CITY OF DALLAS LANDMARK COMMISSION

Monday, March 5, 2018 AGENDA

Request #1 – Existing Metal Canopy to be Removed

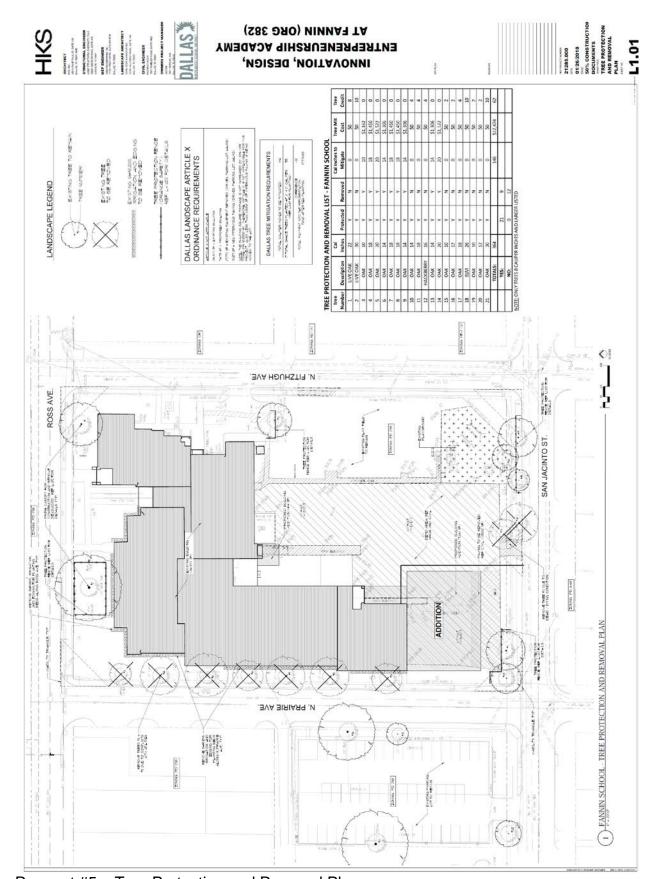
- 1. Remove non-historic metal canopies at south elevation of school.
- 2. Remove four windows from west elevation of 1990s rear addition and infill with brick.
- 3. Remove four windows from east elevation of 1990s rear addition and infill with brick.
- 4. Repave parking lot and walkways, including addition of new driveway approach at east elevation.
- 5. Install new landscaping.
- 6. Install new metal panels with signage on existing chiller enclosure.
- 7. Install new metal canopy at rear elevation.
- 8. Construct vestibule addition at rear entry on south elevation.
- 9. Construct gym addition at south elevation of 1990s rear addition.
- 10. Construct stairs and ramp and metal canopy at east elevation of 1990s rear addition.

- Remove non-historic metal canopies at south elevation of school. – Approve – Approve with the finding the proposed work meets the standards in City Code Section 51A-4.501(g)(6)(C)(i).

Request #8 – Elevation Drawings of Proposed Vestibule Addition

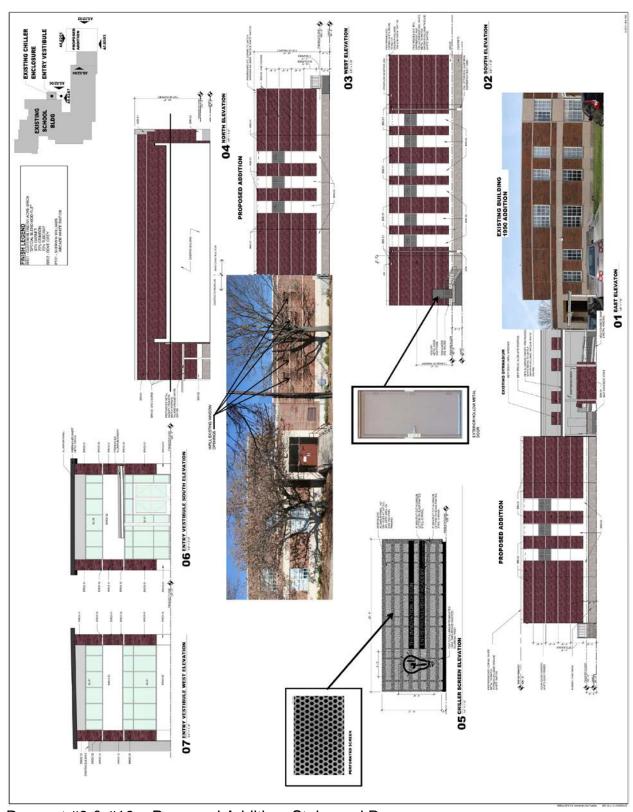
- 1. Remove non-historic metal canopies at south elevation of school. Approve Approve as submitted.
- 2. Remove four windows from west elevation of 1990s rear addition and infill with brick. Approve as submitted. Approve Approve as submitted.
- 3. Remove four windows from east elevation of 1990s rear addition and infill with brick. Approve Approve as submitted.
- 4. Repave parking lot and walkways, including addition of new driveway approach at east elevation. Approve Approve as submitted.
- 5. Install new landscaping. Approve Approve as submitted.
- 6. Install new metal panels with signage on existing chiller enclosure. Approve Approve as submitted.
- 7. Install new metal canopy at rear elevation. Approve Approve as submitted.
- 8. Construct vestibule addition at rear entry on south elevation. Approve Approve as submitted.

Request #1-#7 - Proposed East Elevation of Historic Structure

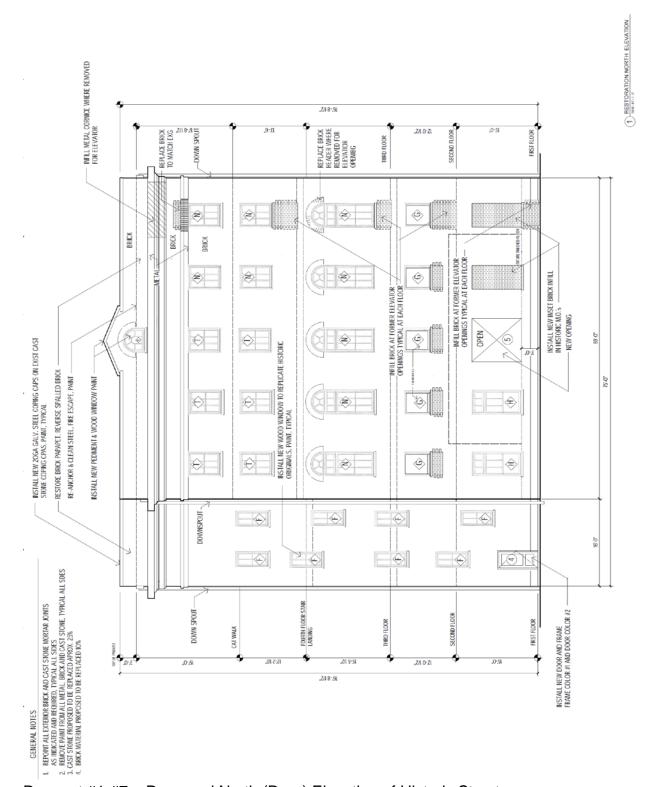
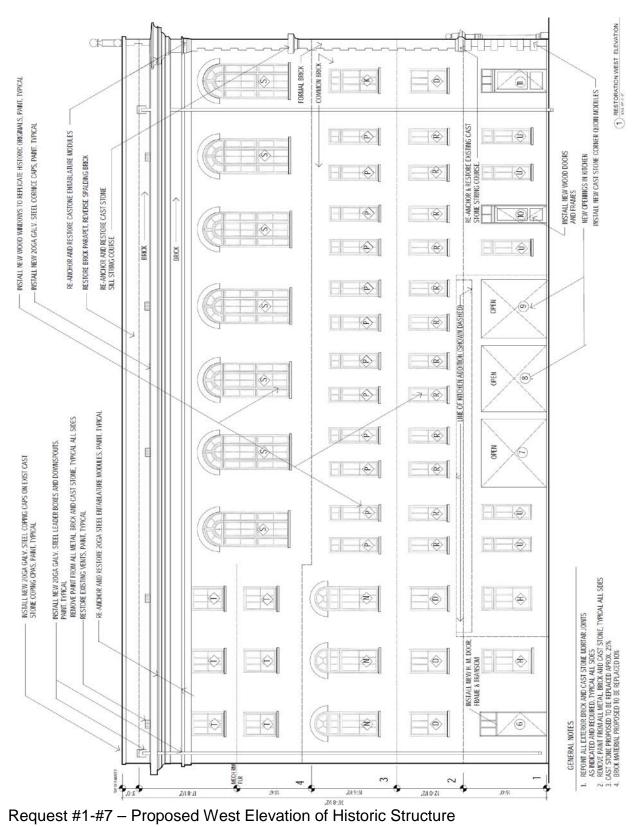
- 1. Remove original metal fire escape on north elevation.
- 2. Remove existing non-historic elevator shaft addition on north elevation.
- 3. Remove non-historic canopy on south elevation.
- 4. Remove non-historic addition on east elevation.
- 5. Modify original window openings on north.
- 6. Create new window and door openings west elevations.
- 7. Install new wood entry doors and transoms on south,

- 1. Remove original metal fire escape on north elevation. Approve Approve drawings dated 2/12/18 with the finding the proposed work meets the standards in City Code Section 51A-4.501(g)(6)(C)(i).

- 2. Remove existing non-historic elevator shaft addition on north elevation. Approve Approve drawings dated 2/12/18 with the finding the proposed work meets the standards in City Code Section 51A-4.501(g)(6)(C)(i).

- Remove non-historic canopy on south elevation. Approve – Approve drawings dated 2/12/18 with the finding the proposed work meets the standards in City Code Section 51A-4.501(g)(6)(C)(i).

- 4. Remove non-historic addition on east elevation. Approve Approve drawings dated 2/12/18 with the finding the proposed work meets the standards in City Code Section 51A-4.501(g)(6)(C)(i).

Request #1: Replace roof ridge cap with copper ridge cap.

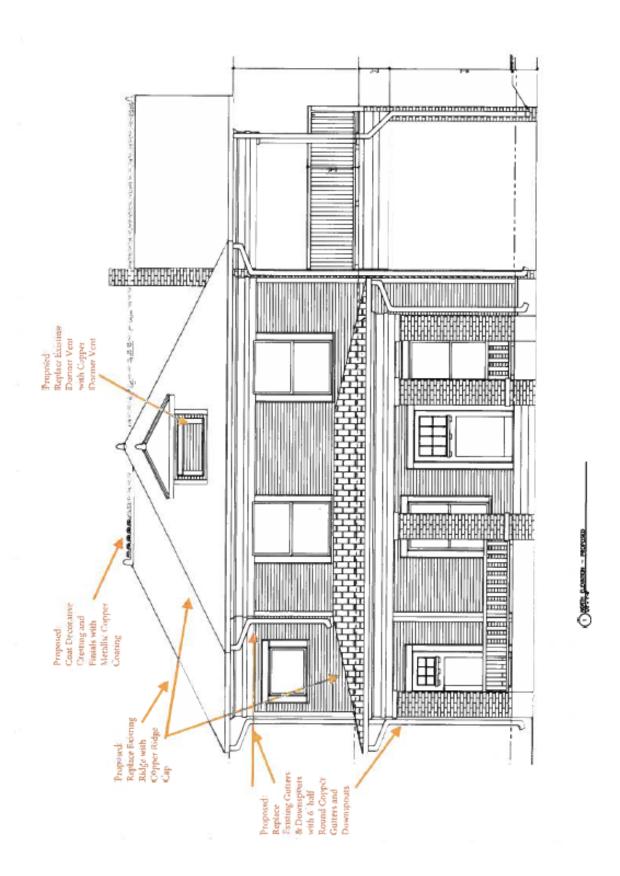
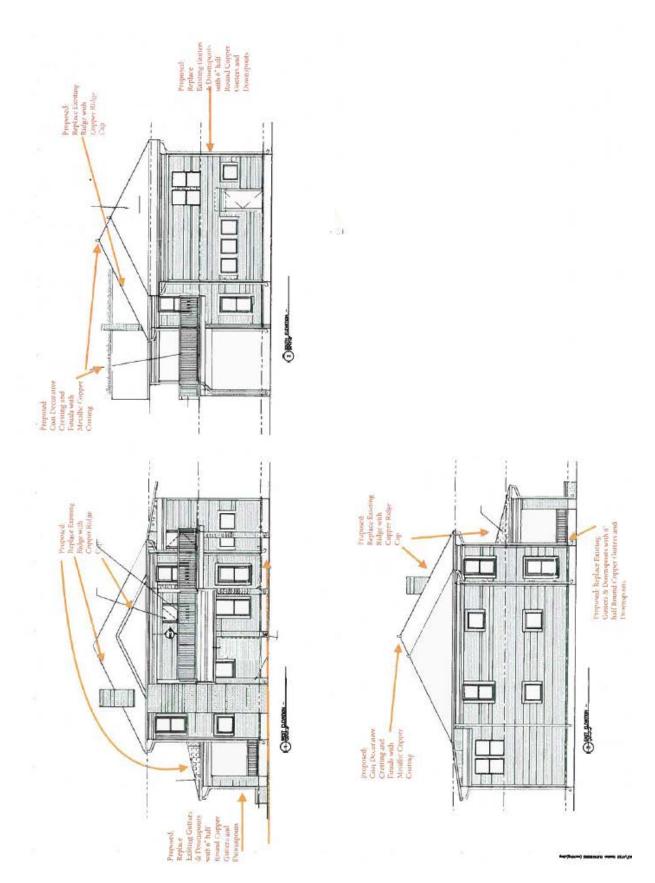
- 1. Replace roof ridge cap with copper ridge cap -Approve with conditions - Approve drawings and specifications dated 02/13/2018 with the condition the existing ridge cap profile is maintained with the finding the proposed work is consistent with the criteria for roofs in preservation criteria Section 3.17, and it meets the standards in City Code Section 51A-4.501(a)(6)(C)(i).

- 1. Replace roof ridge cap with copper ridge cap. -Approve - Attempts to match existing profile if possible
- 2. Paint decorative roof cresting and finials. Brand: Sculpt Nouveau. Color: Metallic Copper B coating. -Approve.
